Sprague River Parking Lot Project Addendum #1

NOTICE TO ALL BIDDERS AND PLANHOLDERS

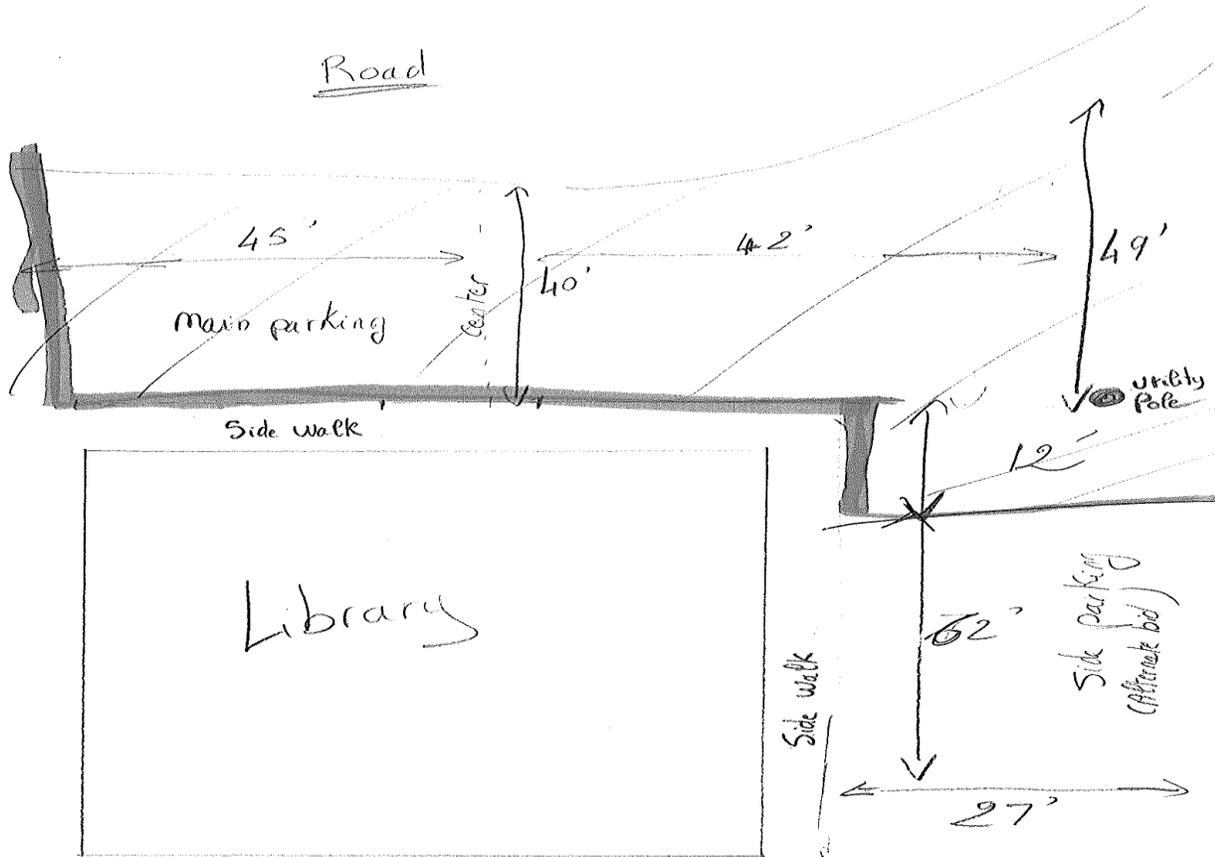
1. Specs at 6 inches of rock and 3 inches of asphalt.
2. Preserve the Hitching posts in the front of the building.
3. Asphalt disposal will be at the Klamath Landfill.
4. Please see below drawing for parking lots estimated measurements;

Specs = 6" Rock / 3" Asphalt
